# Response to Submissions

## Loreto Normanhurst Master Plan

Prepared for Loreto Normanhurst / 15 January 2020

Figure 6.2: Comparison of PUDO Queue Lengths

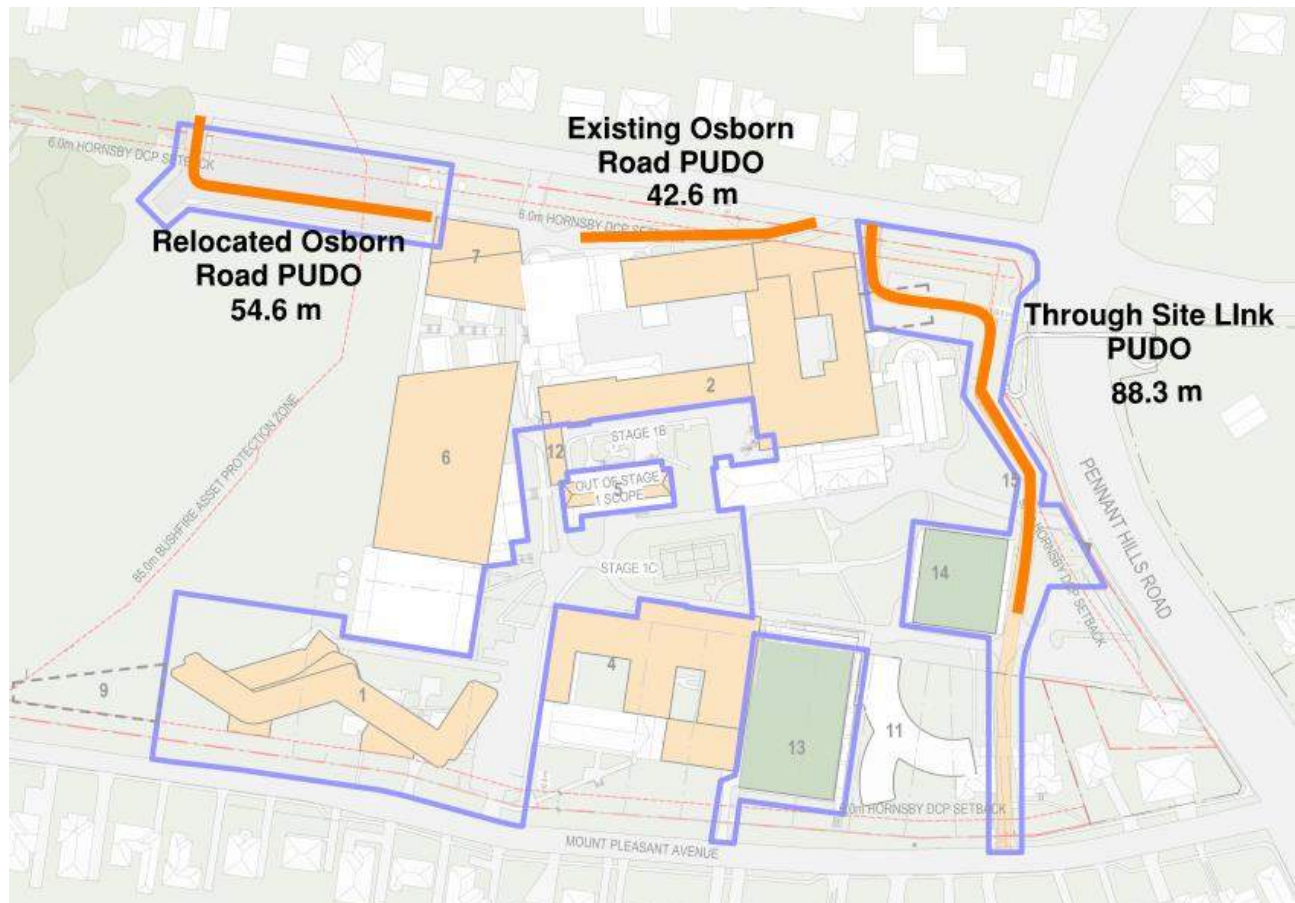
Item	Response
Existing pick up operation is to be reviewed and improved.	<p>Since the original Transport Assessment Report, the existing pick up and drop off arrangement at Osborn Road has been reviewed in its current operation and for its adequacy for the future operations at the School.</p> <p>To address the pick up and drop off issues and future demands Loreto has proposed a relocation of the existing facility and an additional through site link to further increase on site capacity.</p>
With 42.5% increase in students it can be argued that there will be a significant increase in queue length, this is not acceptable to the Branch as it would result in the pickup queue extending onto Osborn Road. Council has received many complaints from local residents regarding queuing onto Osborn Road issue during pickup time.	<p>The relocated Osborn Road pick up and drop off and proposed additional through site link facility will increase the queuing capacity on site by five times what it is currently.</p> <p>Shifting the Osborn Road facility further south will also provide greater departure length from the Osborn Road/Pennant Hills Road intersection which will prevent queues from blocking vehicles entering Osborn Road.</p> <p>These works have been proposed as part of Stage 1 to help ameliorate existing impacts that are experienced by the residents of Osborn Road.</p>

Item	Response
<p>The Department notes that a significant number of additional cars would require the drop-off / pick-up zone access in the future. It will be necessary for the concept proposal to demonstrate that the capacity of the existing drop-off / pick-up zone within the site can accommodate additional cars.</p>	<p>To address the pick up and drop off issues and future demands Loreto has proposed a relocation of the existing facility and an additional through site link to further increase on site capacity.</p> <p>The relocated Osborn Road pick up and drop off and proposed additional through site link facility will increase the queuing capacity on site by five times what it is currently.</p> <p>Shifting the Osborn Road facility further south will also provide greater departure length from the Osborn Road/Pennant Hills Road intersection which will prevent queues from blocking vehicles entering Osborn Road.</p> <p>These works have been proposed as part of Stage 1 to help ameliorate existing impacts that are experienced by the residents of Osborn Road.</p>

The proposed Osborn Road pick up will provide for 2 designated pick up and drop off spaces with sufficient queuing area prior to the spaces internal to the School for 12 vehicles. This will be completed within Stage 1

of the works. The proposed through site link that will be completed during Stage 2 will provide 3 pick up and drop off spaces with queuing area for an additional 24 vehicles.

This supply represents a significant increase in queuing capacity internal to the school as the current facility provides only 4 pick up and drop off spaces with queuing capacity for only 3 vehicles. A comparison of the different queue lengths available is shown in Figure 6.2.

In Stage 5 when adjustments are made to the P3A car park, a pick up and drop off area of equal or increased length will be provided dependent on travel mode surveys that will be conducted throughout the staged developments.
